STAFF REPORT
COMMUNITY DEVELOPMENT DEPARTMENT

SUBJECT: SHP-2022-0010
 Idak Subdivision

Short Plat request to subdivide an existing single-family building lot into two (2) single-family building lots on approximately 2.09 acres in the R-2 zoning district, by Sawtooth Land Surveying.

A. Short Plat (dated: ~~August~~ October 2022)

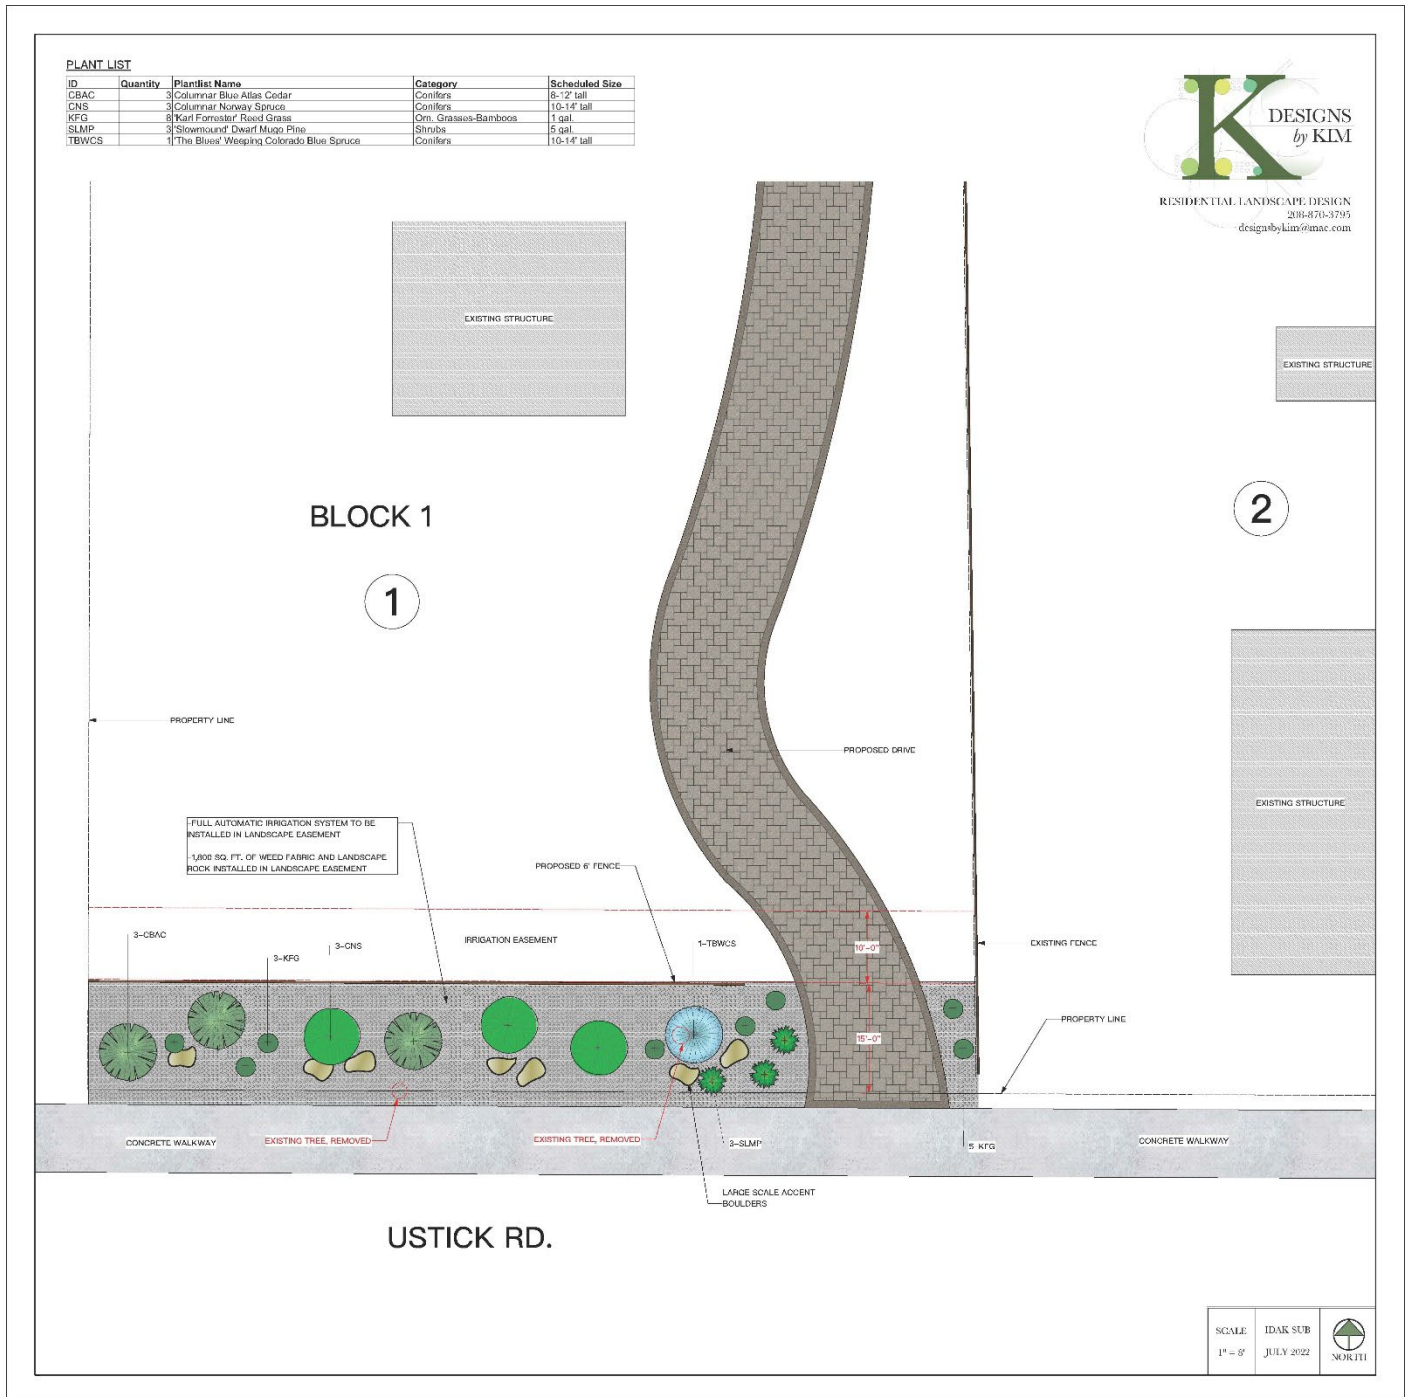
Current access to the property is through a shared driveway along the southeast corner of the property that is located on the adjoining county parcel to the east, 870 E. Ustick. However, according to the submitted plat, the access easement is on the subject property with a portion of the easement encroaching on the corner of the existing home and not on the adjacent county parcel. With the subject applications, the Applicant is proposing a new access for the new building lot located where the current curb cut exists to Ustick near the midpoint of the south property line.

UDC 11-3A-3 requires properties that currently take direct access to arterial streets to take access from a local street upon development. In this case, no existing local streets are available to take access from and Staff finds requiring this property owner to create a new local street would create minimal opportunities for future extension nor provide access to a relevant number of properties. Further, the intent of UDC 11-3A-3 is to “improve safety by combining and/or limiting access points to collector and arterial streets and ensuring that motorists can safely enter all streets.” Therefore, Staff is recommending the following revisions to the proposed access consistent with UDC standards:

1. Relinquish existing rights to the shared access easement with 870 E. Ustick;
2. Add a common drive, within a common lot, along the west and north property boundaries of the proposed Lot 2, the lot containing the existing home;
3. Show existing home and proposed home to take access from new common drive instead of the shared access to the east; and,
4. Add a note to the plat stating cross-access for the proposed building lots (Lots 1 & 2) and for access to 870 E. Ustick, consistent with UDC 11-3A-3.

4. The short plat prepared by Sawtooth Land Surveying in August, 2022 by Fritz Brownell, included in Section VI.A, shall be revised as follows:
 - a. Add a common drive, within a common lot, along the west and north property boundaries of the proposed Lot 2, the lot containing the existing home, substantially consistent with the exhibit in VI.C above OR obtain Alternative Compliance approval to place the common drive within an easement instead of a common lot consistent with the revised plat, as depicted in Exhibit VI.A above.

- b. Show existing home and proposed home to take access from new common drive.
 - c. Add a plat note granting cross-access for the proposed building lots (Lots 1 & 2) of this subdivision and 870 E. Ustick to utilize the new common drive.

B. Landscape Plans (dated August 2022):

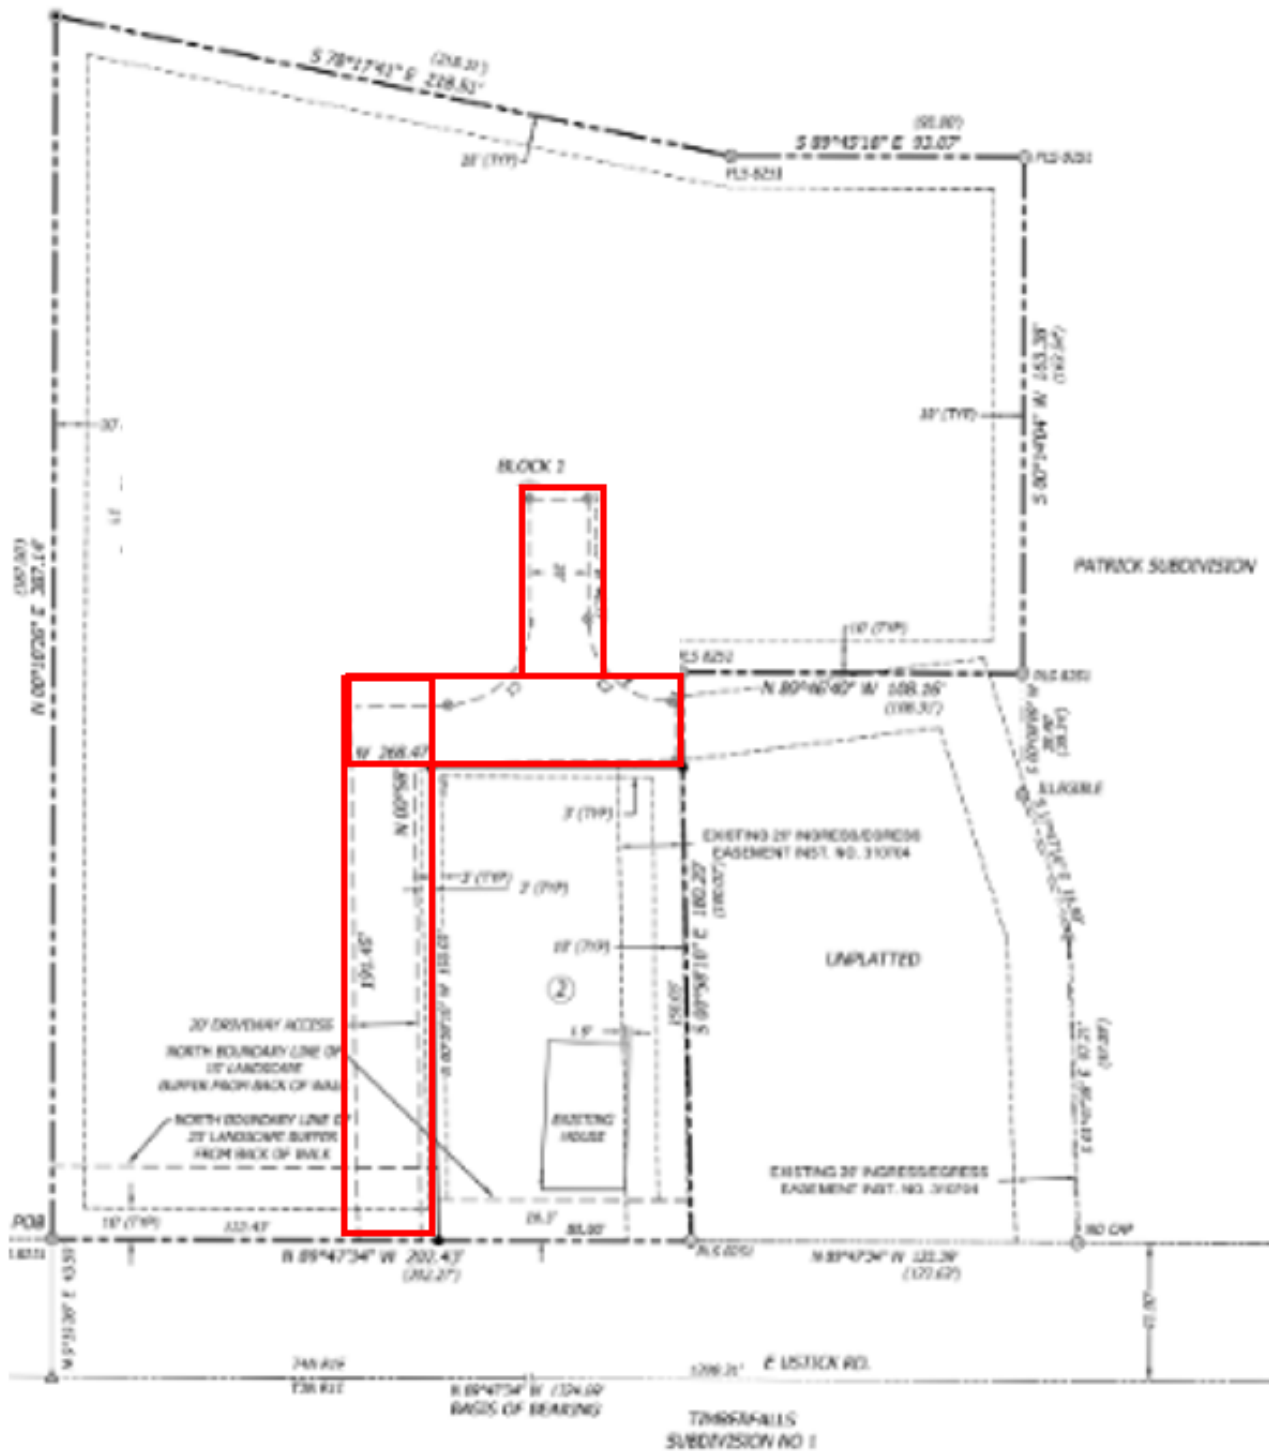
The Applicant has submitted two landscape plans that together depict the proposed landscape buffer along Ustick Road. Per UDC 11-2A-4, a minimum 25-foot wide landscape street buffer is required along Ustick. As discussed above, the Applicant is requesting Alternative Compliance to this requirement for the landscape buffer along Lot 2 for the existing home to comply with UDC dimensional standards. The submitted short plat depicts the required 25-foot landscape buffer on the remaining buffer length but the submitted landscape plan depicts only 15 feet of landscaping along Ustick on Lot 1. Staff does not support a reduction of the landscape buffer along Lot 1 and this area was not included in the ALT request, so the Applicant should revise the landscape plan prior to submitting for plat signature to depict the required 25-foot street buffer width. Further, the submitted landscape plan for Lot 1 does not appear to depict adequate ground cover consistent with UDC 11-3B-7 and UDC 11-3B-5 by depicting landscape rock as the main ground cover material. Therefore, the Applicant should revise the landscape plan to depict adequate ground cover to comply with UDC standards prior to City Engineer's signature on the plat.

According to the submitted landscape plans and plat, the Applicant is depicting a 15-foot wide landscape buffer along Ustick to be contained within an easement, as allowed by UDC 11-3B-7. This buffer is shown to depict two trees, a number of columnar trees, and shrubs. Further, placing the landscape buffer within an easement allows the building setback to be measured from the back of sidewalk instead of the back of the buffer; therefore, the landscape buffer will not create a setback nonconformity for the existing home since it is approximately 17 feet from the back of sidewalk.

6. Prior to submittal for the City Engineer's signature on the plat, revise the landscape plans to depict the required 25-foot wide buffer along Ustick Road on Lot 1 per UDC Table 11-2A-4 and vegetated in accord with UDC 11-3B-5 & 11-3B-7 standards.
